CONSUMERS POWER COMPANY
Docket 50-155
Request for Change to the Technical Specifications
License DPR-6

For the reasons hereinafter set forth, it is requested that the Technical Specifications contained in Facility Operating License DPR-6, Docket 50-155, issued to Consumers Power Company on May 1, 1964, for the Big Rock Point Plant be changed as described in Section I below:

ATTACHMENT 1

Figure 6.2-1

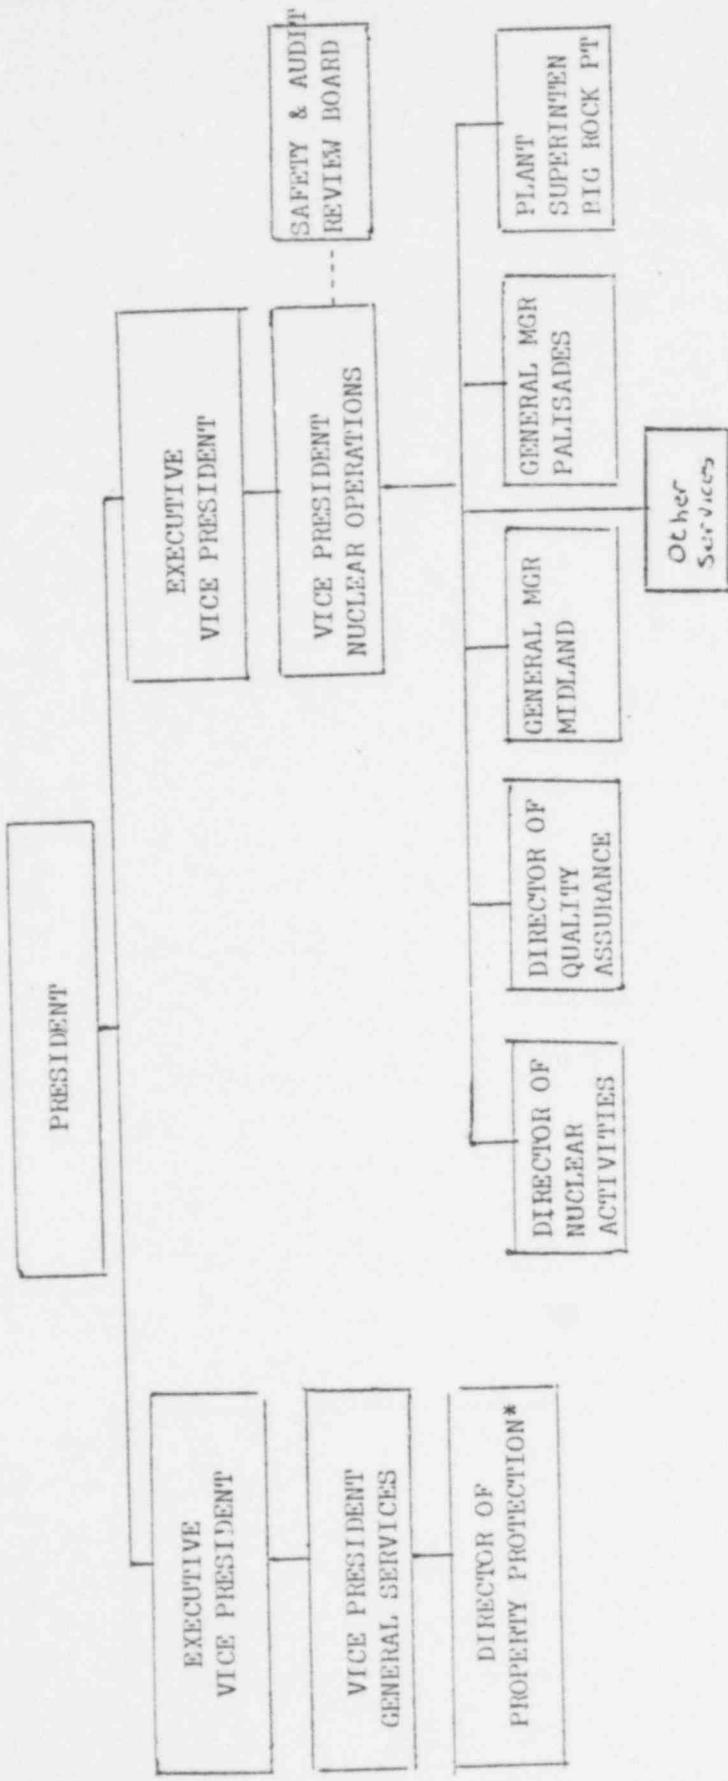
All proposed changes within the text of the Administrative Controls Section (Chapter 6) of the Technical Specifications are consistent with the changes on the organization charts (Figures 6.2-1 and 6.2-2).

Figure 6.2-1
Figure 6.2-2
Section 6.5.1.2
Section 6.5.1.6.e
Section 6.5.1.7.c
Section 6.5.1.8
Section 6.5.2.1
Section 6.5.2.3
Section 6.5.2.4
Section 6.5.2.9
Section 6.5.2.10
Section 6.5.2.11.a
Section 6.5.2.11.b
Section 6.5.2.11.c
Section 6.6.1.b
Section 6.7.1.b
Section 6.7.1.d

Figure 6.1-2

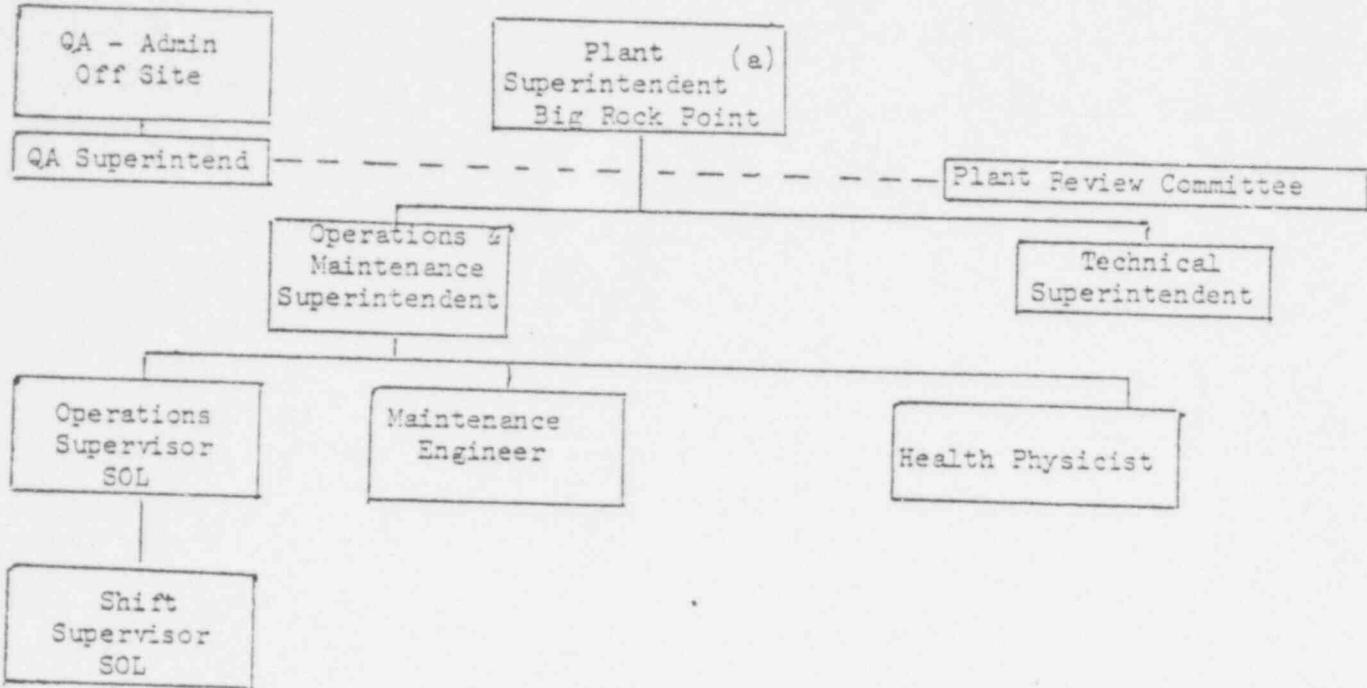
The proposed plant organization parallels that currently used at our Midland Plant. Under the proposed organization, responsibilities of the Plant Superintendent and the Operations & Maintenance Superintendent are modified. The Plant Superintendent is responsible for the safe, reliable and efficient operation of the Big Rock Point Plant. The Operations & Maintenance Superintendent is responsible for coordinating the efforts of the operations, maintenance and health physics functions of the plant. Personnel who have responsibility in these operational, maintenance and radiation protection areas report to the Operations & Maintenance Superintendent. This represents an enhancement of management attention to safety and radiation protection because the Operations & Maintenance Superintendent will not be responsible for the administrative functions to be handled by the Plant Superintendent or other personnel reporting to the Plant Superintendent.
